Livestock Plaza/Sheep Barn

Addendum Issue Date: 8/8/24

The following changes, revisions, or clarifications shall be made to the drawing documents.:

BUILDING ELEVATIONS
SHEET NAME:
FULL-SCALE: 22x34
HALF-SCALE: 11x17
DRAWING MAY NOT BE PRINTED TO SCALE

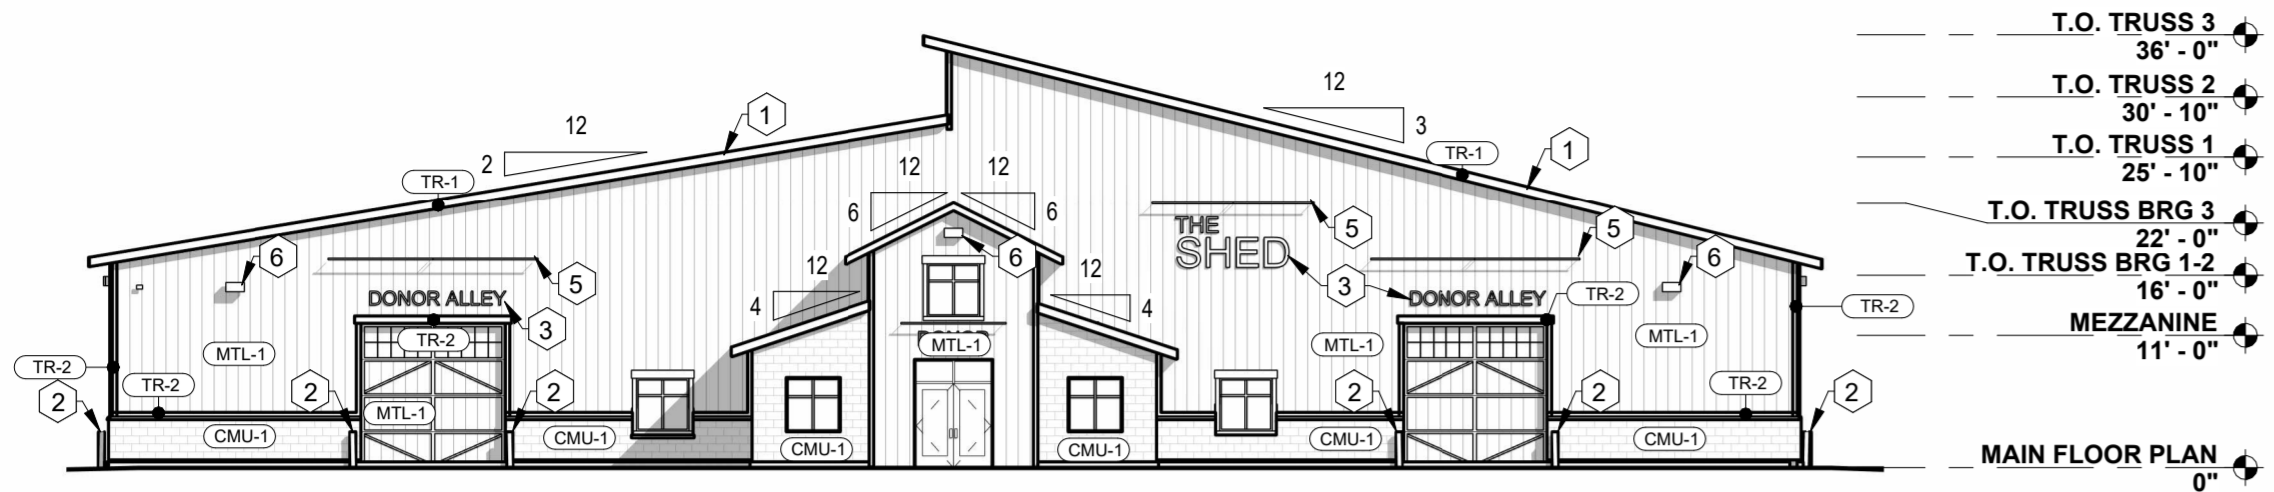
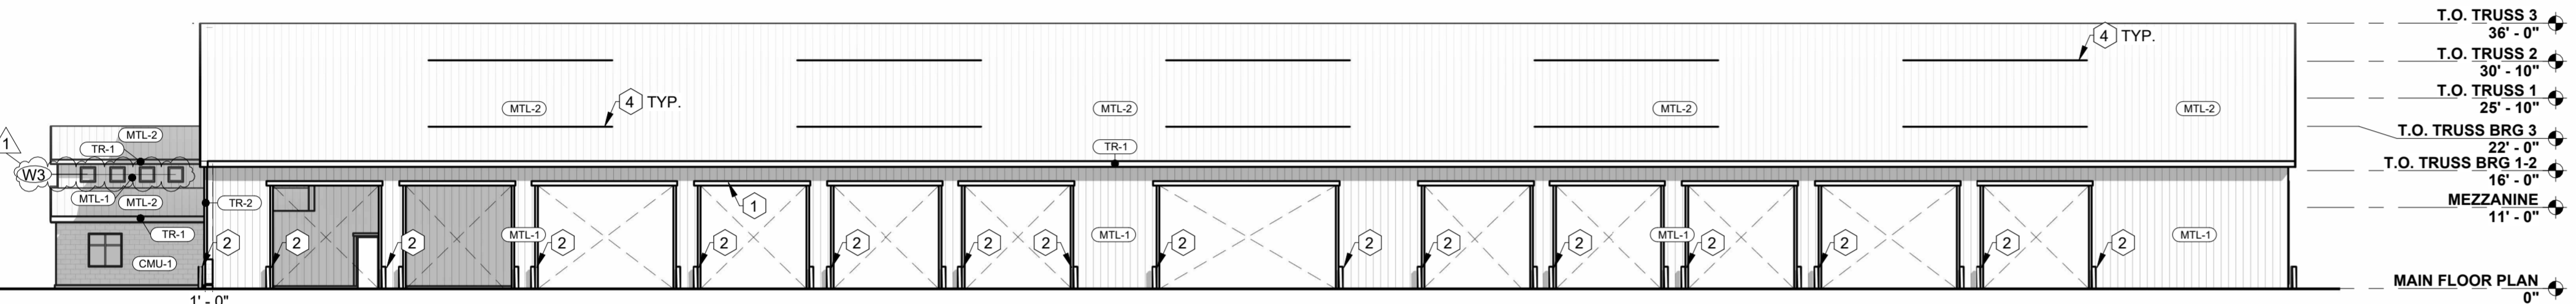
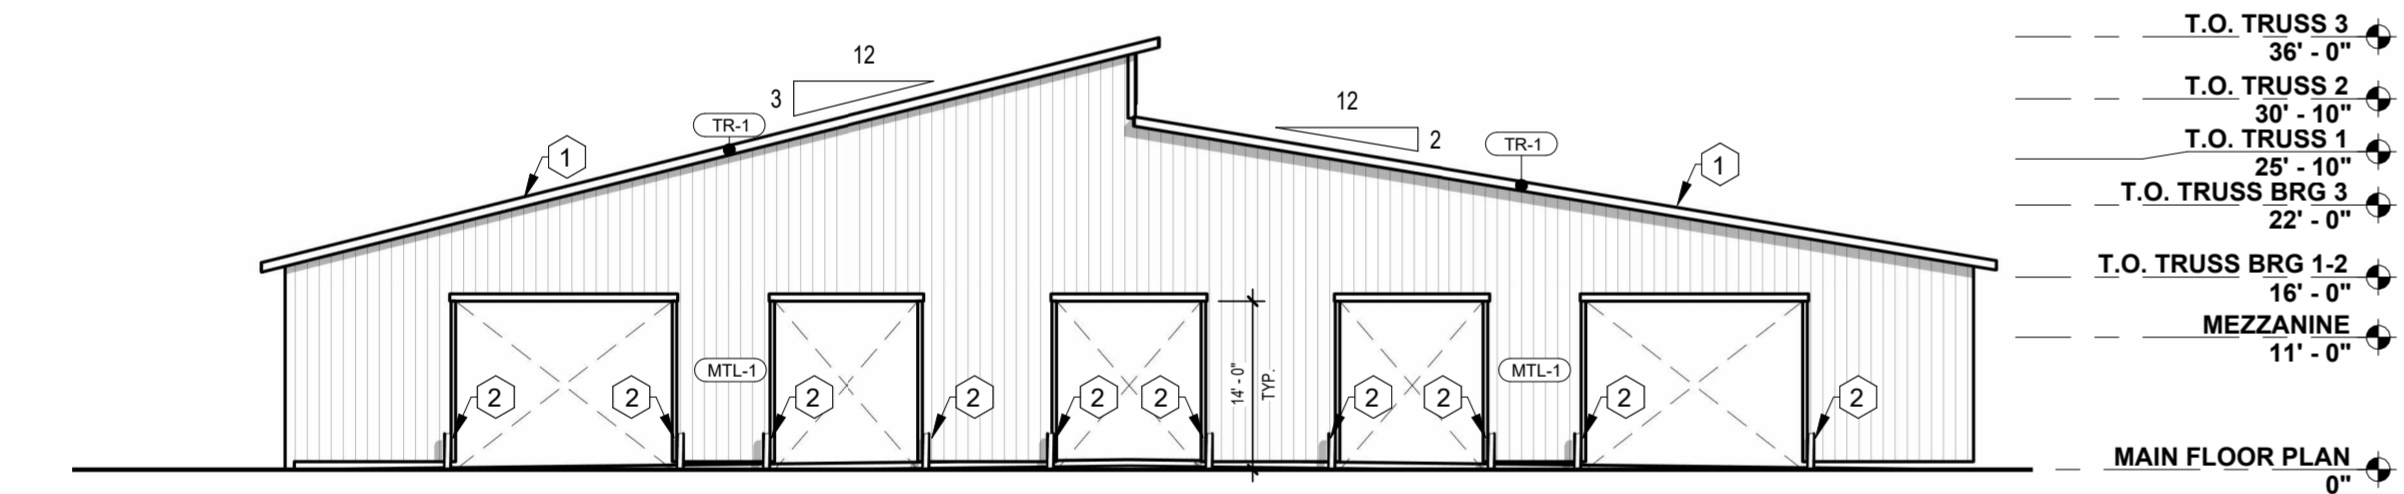
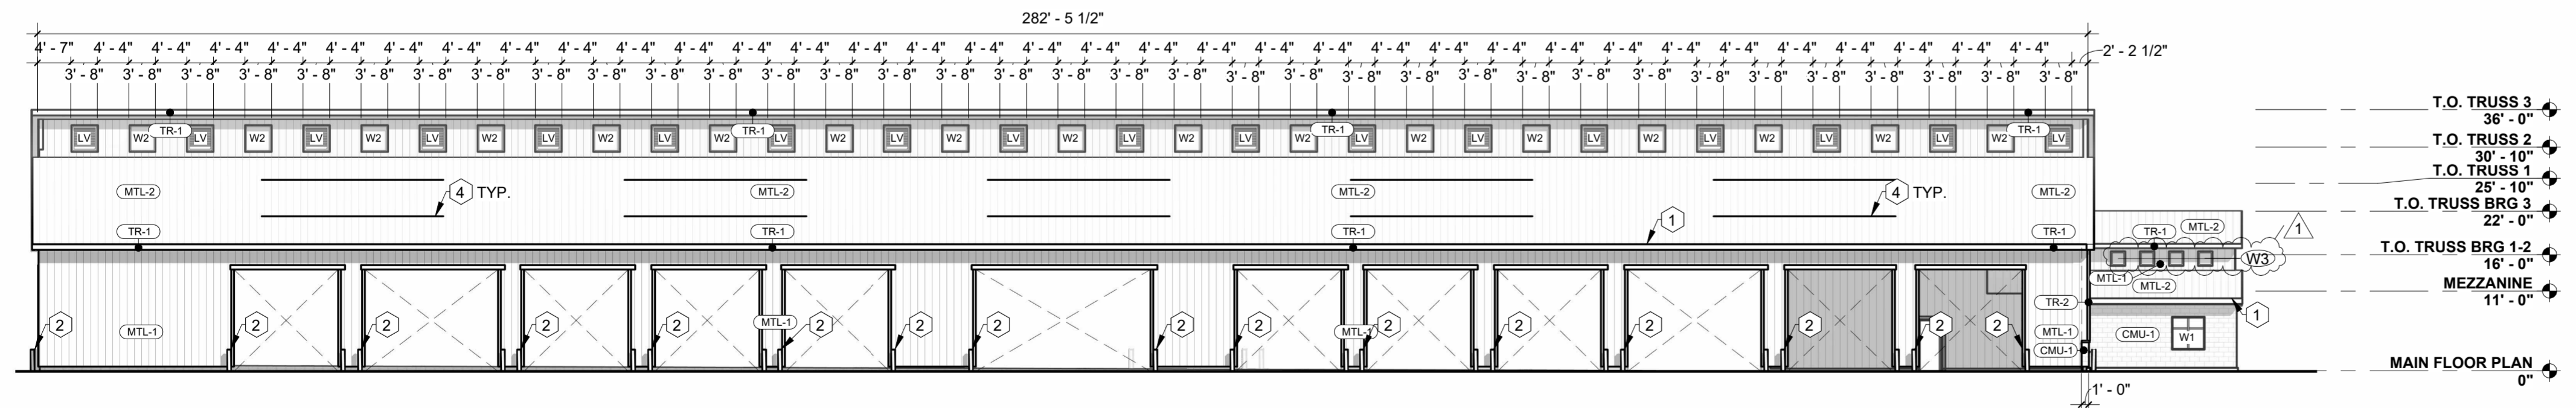
Sheet A4.1 - Building Elevations:

Material tag for trim have been revised.
